# Mike Turtur Bikeway Overpass Project Community Reference Group Report

- This document provides an overview of the Mike Turtur Bikeway Overpass (MTBO) project Community Reference Group (CRG) process and a summary of the insights shared by CRG members.

## Northern design straight ramp (Option 3a)

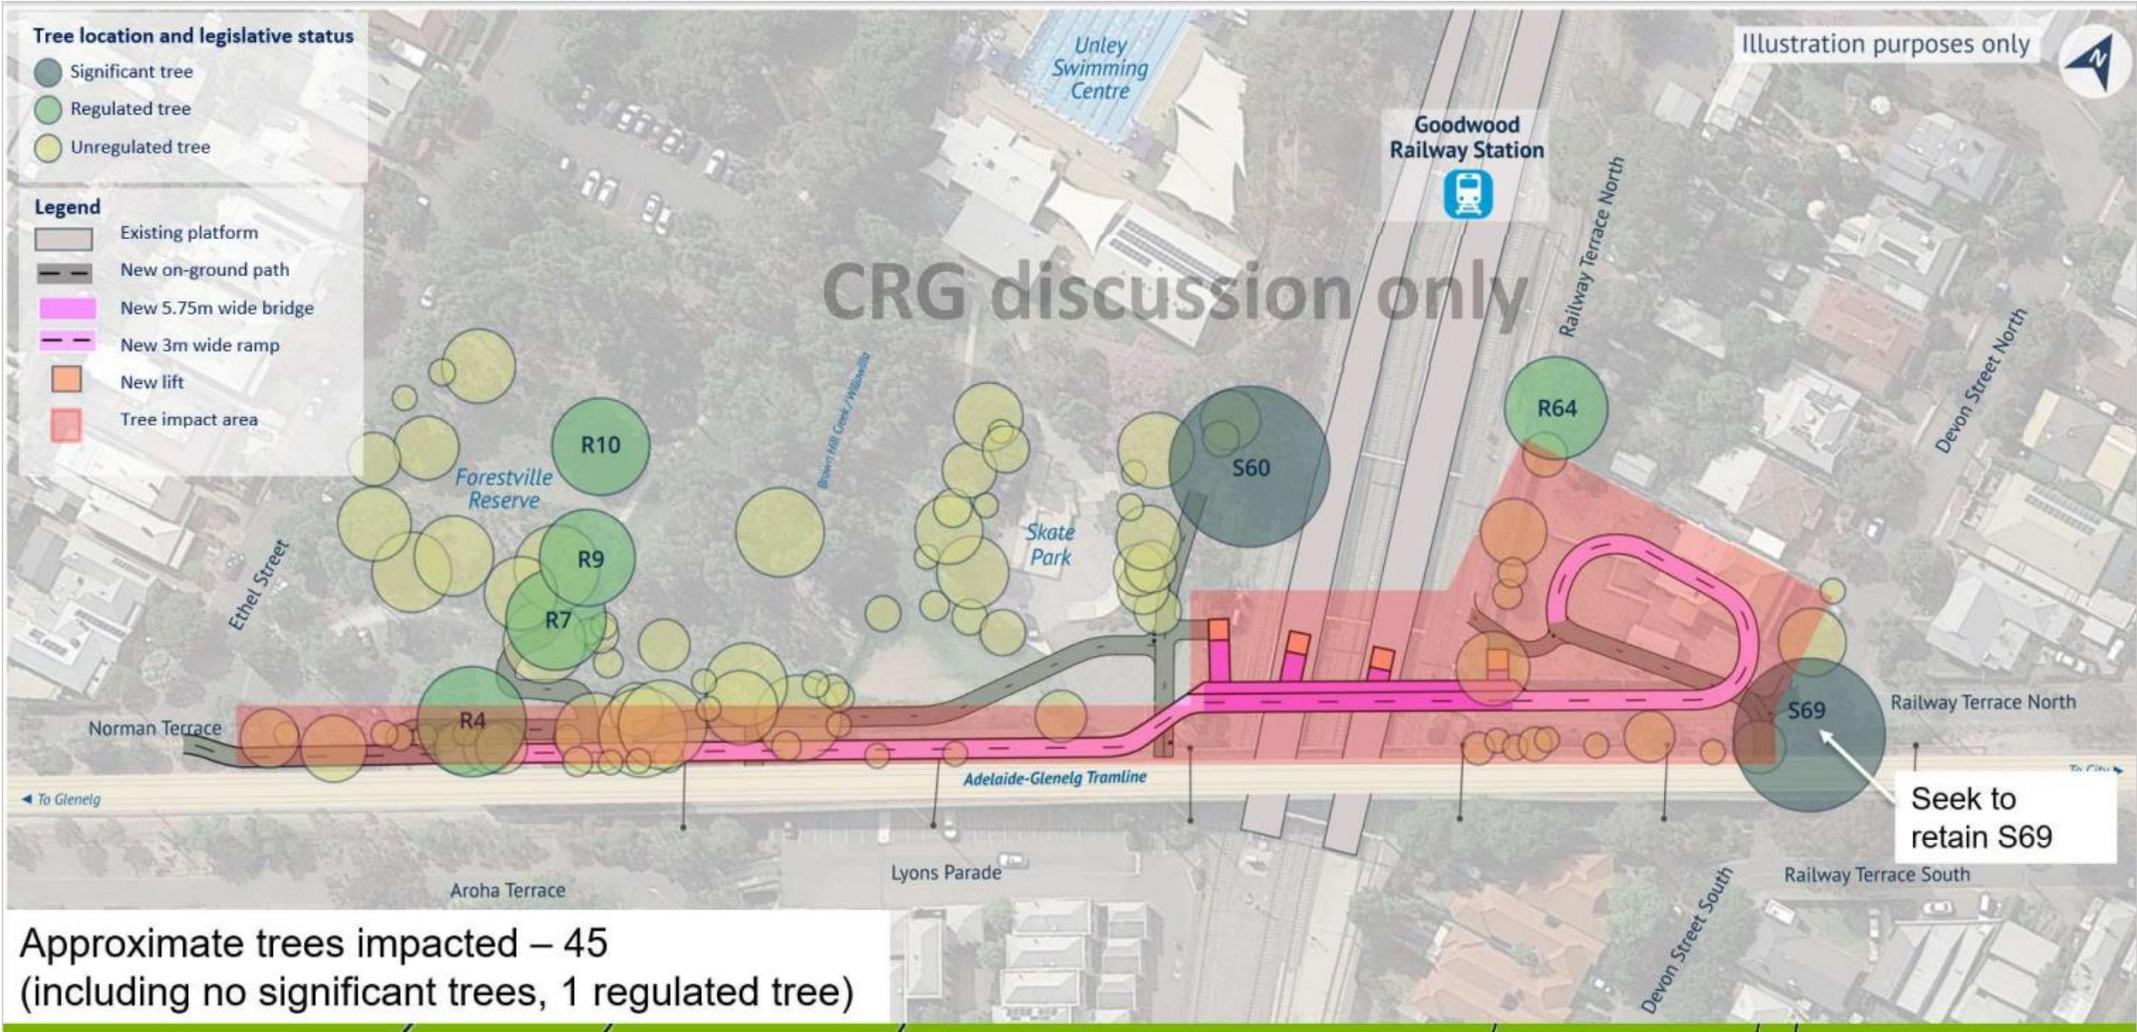
Approximate trees impacted – 40  
 (including 1 significant tree (would seek to retain), 1 regulated tree)

South and north design (Option 5b)

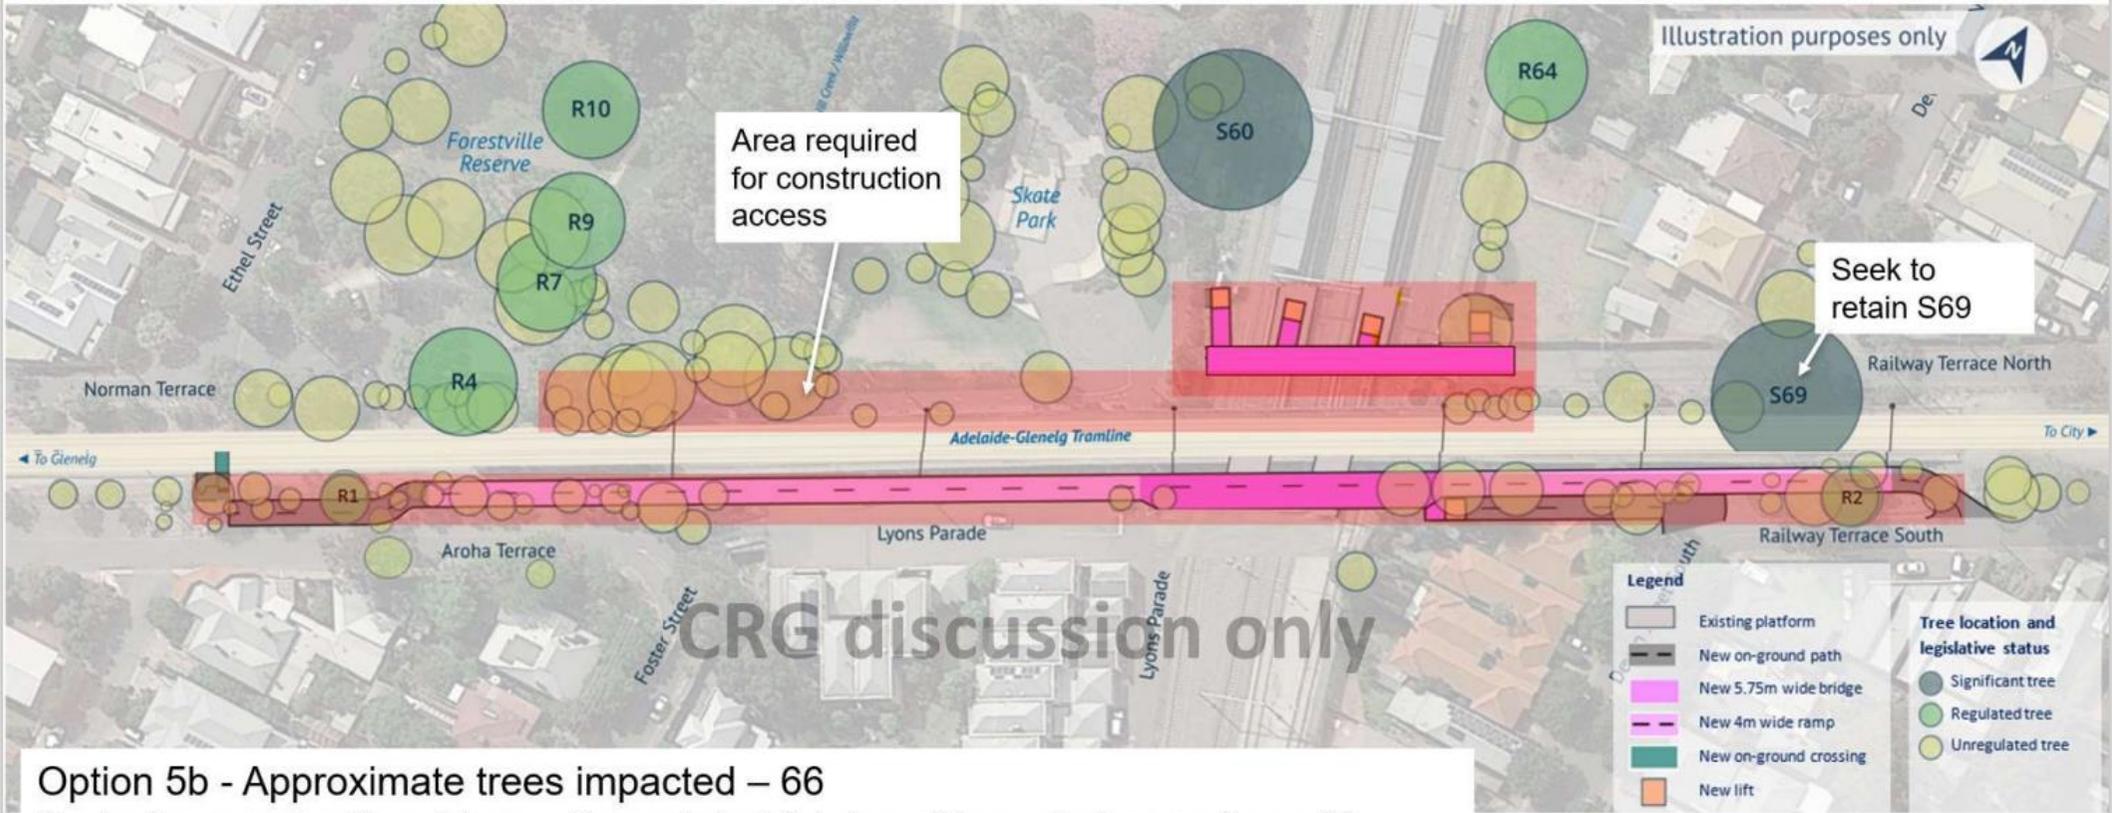
Option 5b - Approximate trees impacted – 66  
 (including no significant trees, 2 regulated (status of trees to be confirmed))  
 Option 4 (southern design) – Approximate trees impacted – 44  
 (including no significant trees, 2 regulated (status of trees to be confirmed))
